MEMORANDUM

DATE: November 20, 2025
TO: Alfred J. Mittl, PE
Public Works Director
City of Sanibel
FROM: Farzin Zafarianian, PE, Senior Structural Engineer, TYLin
Michael Harter, PE, Transportation Manager, Brindley Pieters & Associates, Inc.
SUBJECT: East Periwinkle Bridge Replacement- Vertical Profile Design

This memorandum presents those potential impacts associated with increasing the vertical clearance for boats from the current design of one foot higher than the existing bridge to three feet higher than the existing bridge as requested by residents. Questions posed by residents are also addressed.

Plan and Cross Section of the Impacted Area

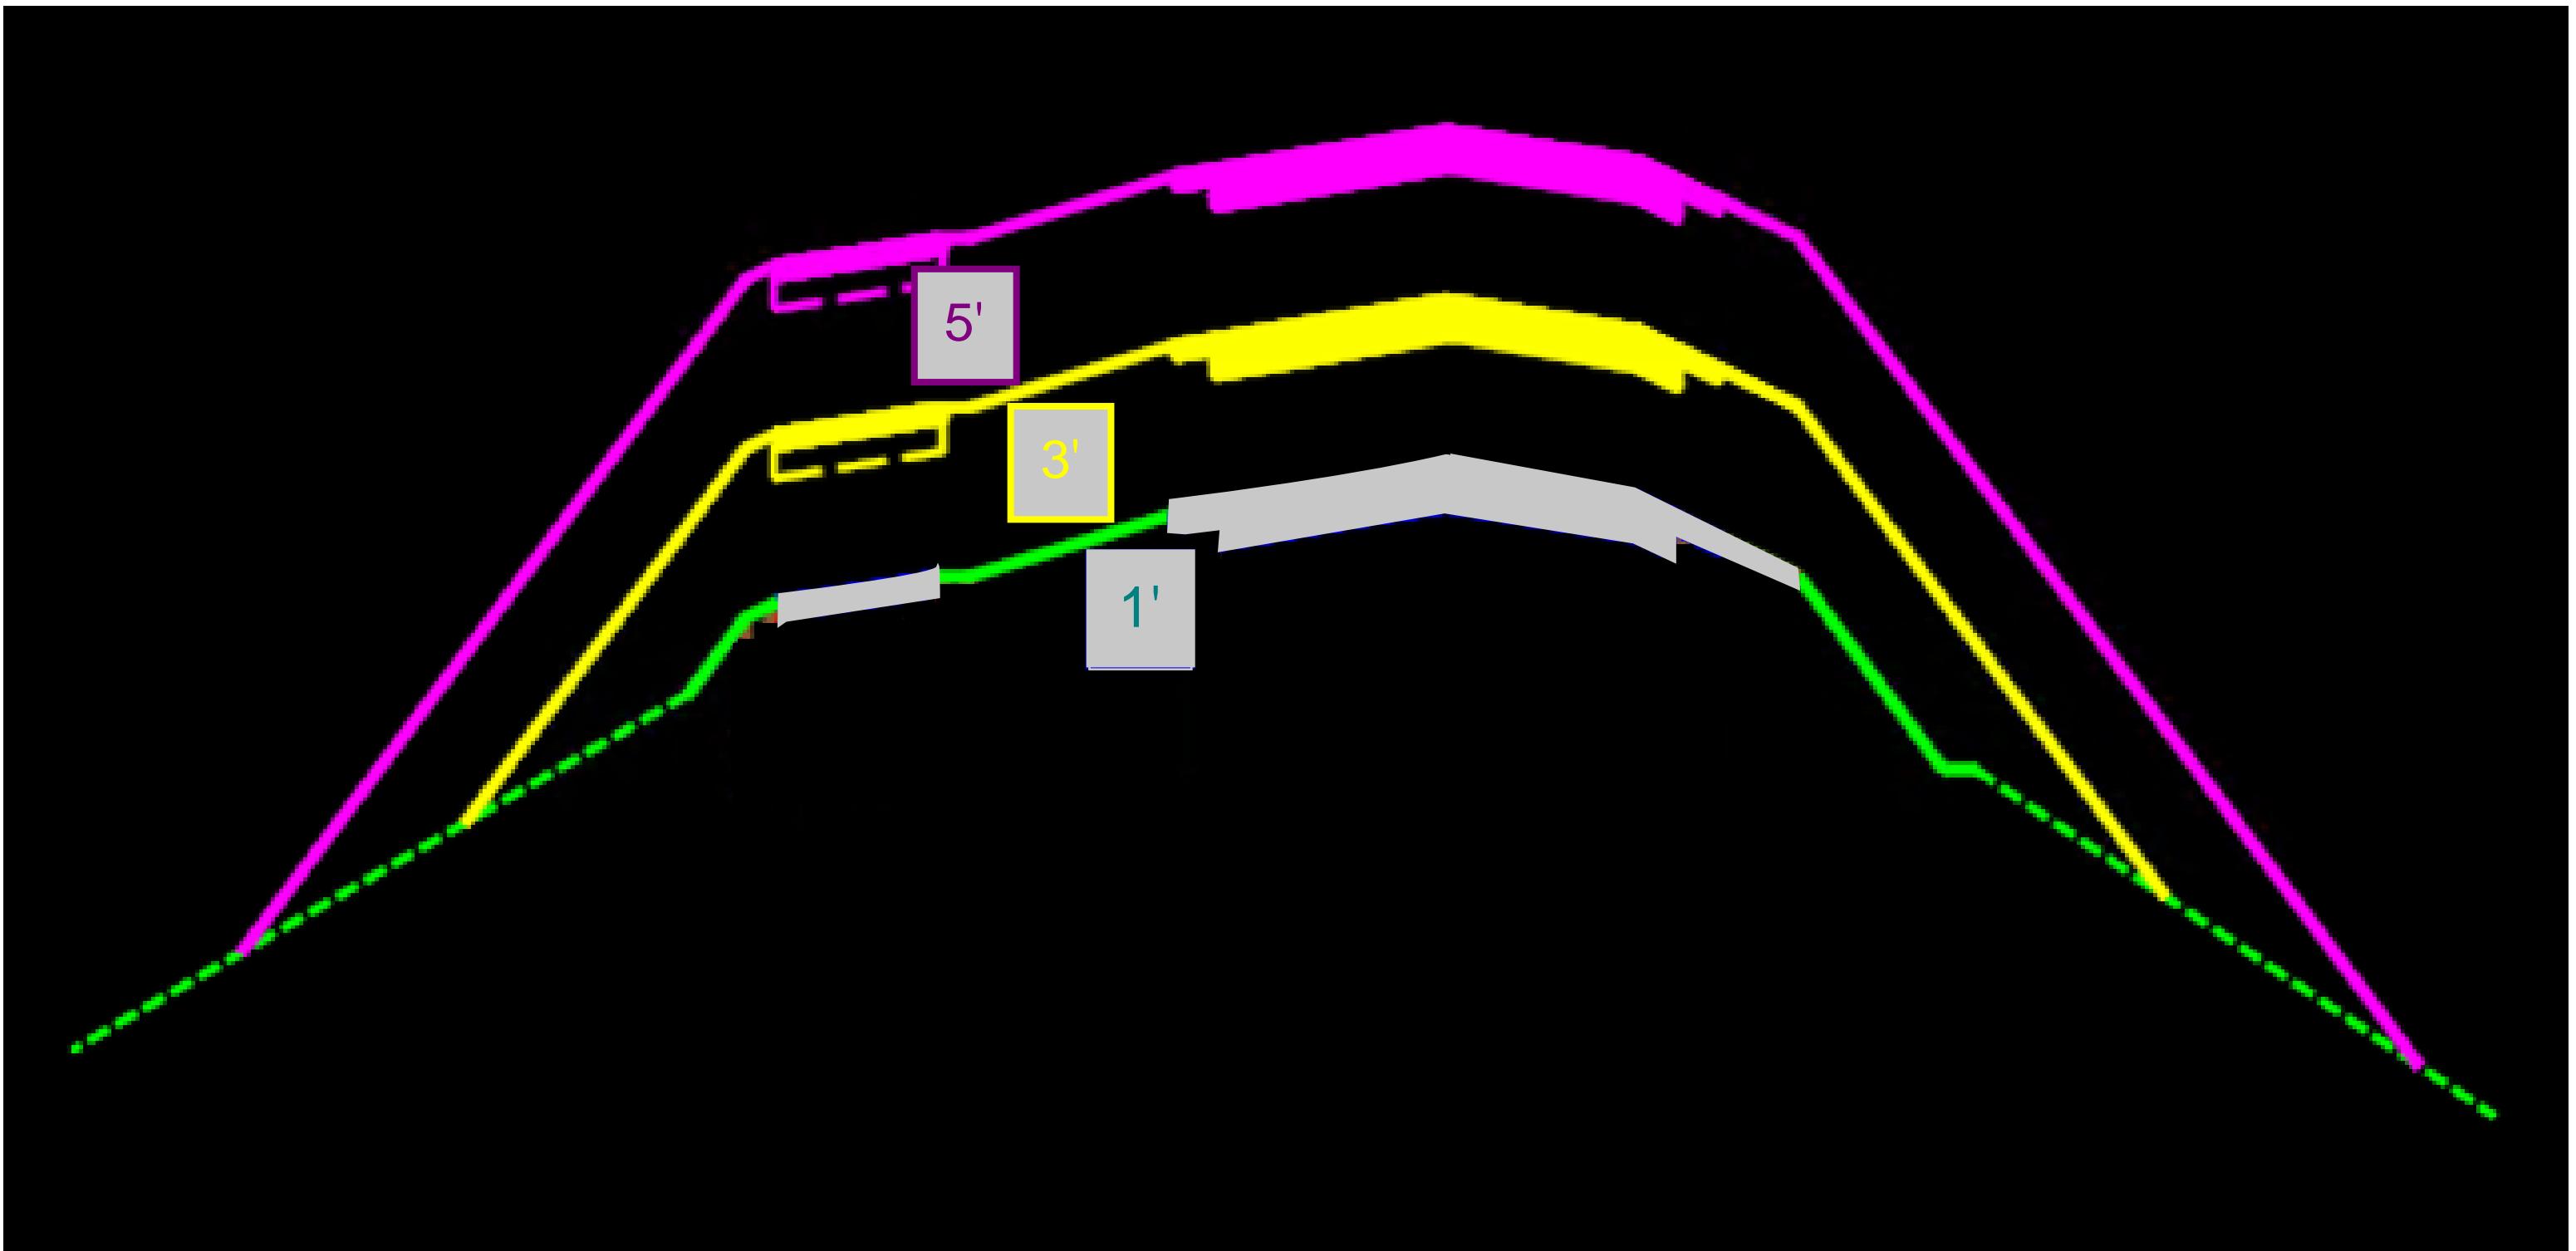
- The green/grey area represents the current design, which achieves the additional one foot of clearance with no expected impact to adjacent intersections or residential properties.
- The yellow and magenta areas indicate the estimated zones of impact if the bridge is raised by three feet and five feet from existing bridge structure, respectively.

As shown, increasing bridge height directly expands the footprint of required grading on both the north and south sides to tie into existing ground elevations. Consequently, the higher the bridge is elevated, the more extensive and disruptive the impact becomes to adjacent properties and roadways.

The projected area of impact extends beyond the City's right-of-way, affecting Pen Shell Drive, Tulip Lane, and Limpet Drive and some residential driveways along these streets due to the resulting grade differences at their intersections with East Periwinkle Way:

Roadway Profile

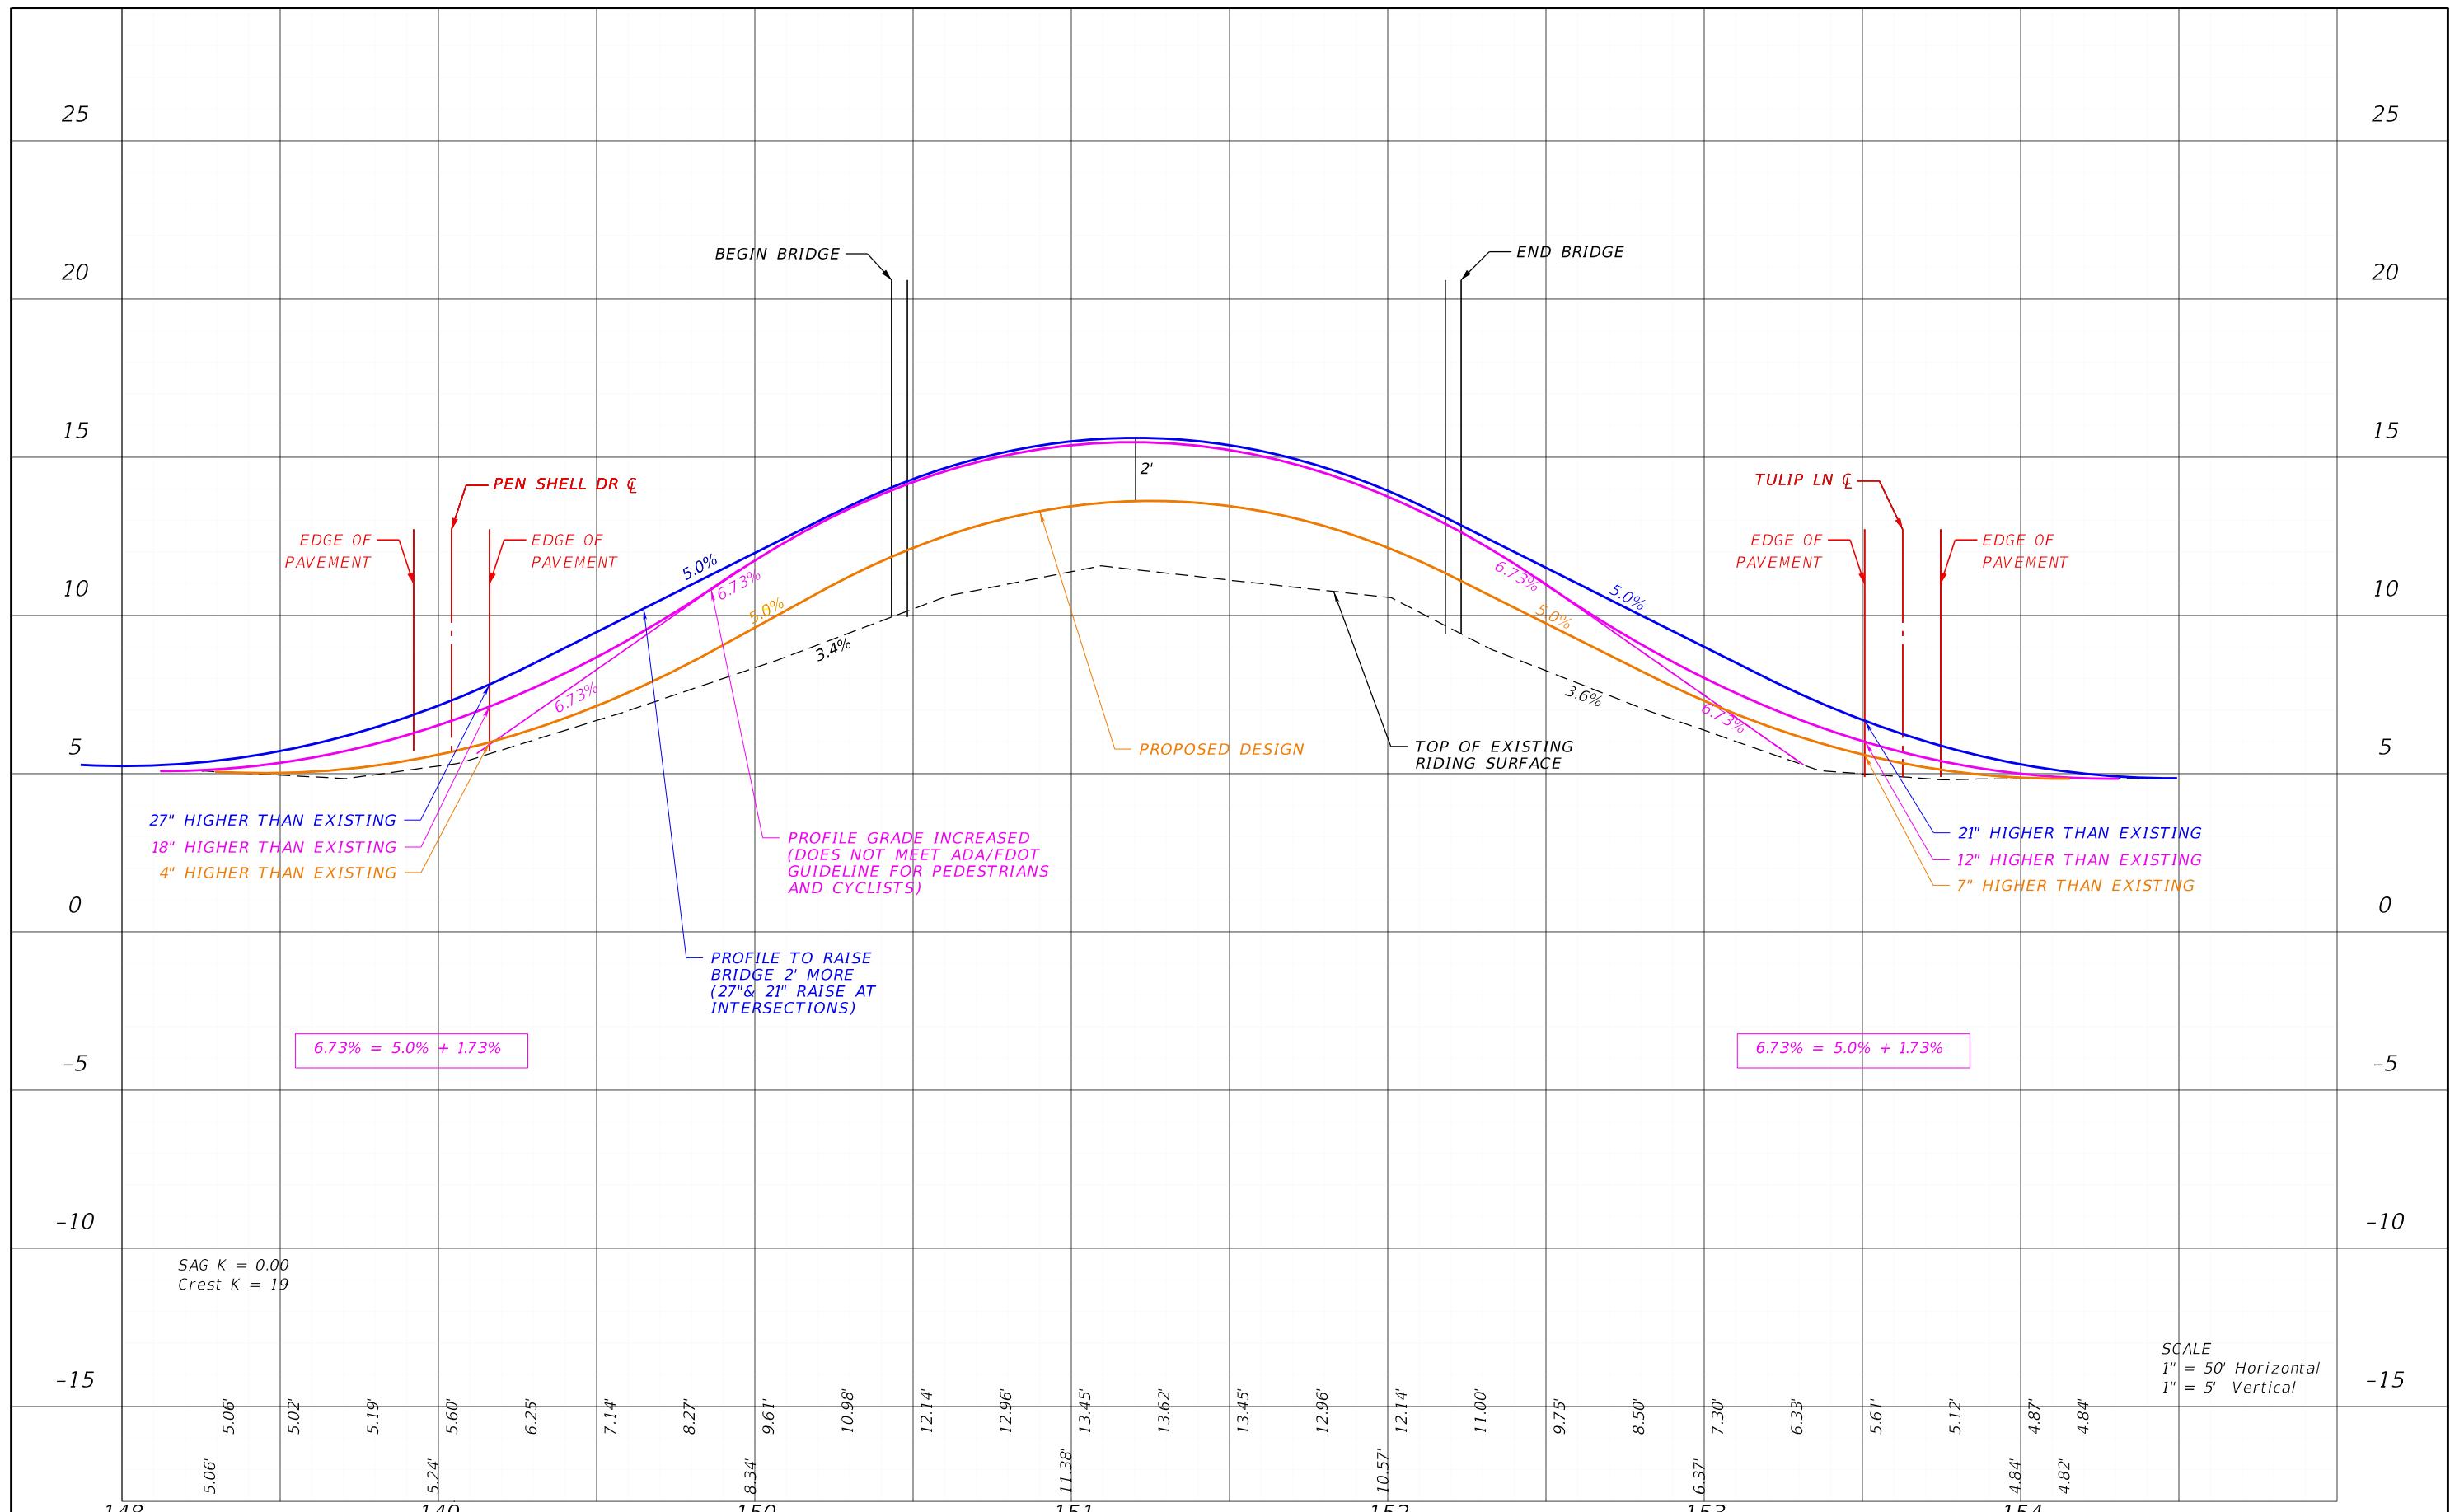
Mr. Kevin McLellan, one of the city residents, sent an email on November 9, 2025 to share his engineering and cost summary findings to show the potential changes due to raising the bridge. A copy of his email and the attachments are included in **Appendix B**. In his engineering summary, Mr. McLellan mentions that raising the bridge by 3.46 feet over a distance of 173 feet, which is his measurement of distance from center of Pen Shell Drive to the bridge abutment, would result in a slope of 1.73%. And he concludes that based

on this small slope increase, there will be minimal to no impact on the side roads and adjacent properties. What Mr. McLellan fails to consider is that this 1.73% slope will be in addition to the current 5% slope in our proposed design.

The roadway profile in **Appendix C** illustrates this concept more clearly. Below is a quick summary of the notations on the profile sheet:

- The dashed profile is the existing bridge.
- The gold profile is the current design using 5% slope. The elevation change to edge of pavement at Pen Shell/Limpet Drive and Tulip Lane are shown to be 4" and 7", respectively.
- The blue profile shows the impact of raising the bridge by 3 feet from existing bridge while maintaining the maximum 5% slope required by code. The elevation change to edge of pavement at Pen Shell Drive and Tulip Lane are shown to be 27" and 21", respectively.
- The magenta color profile shows the concept proposed by Mr. McLellan which would result in a longitudinal slope of 6.73% that exceeds the maximum allowable slope specified in the FDOT Florida Design Manual.
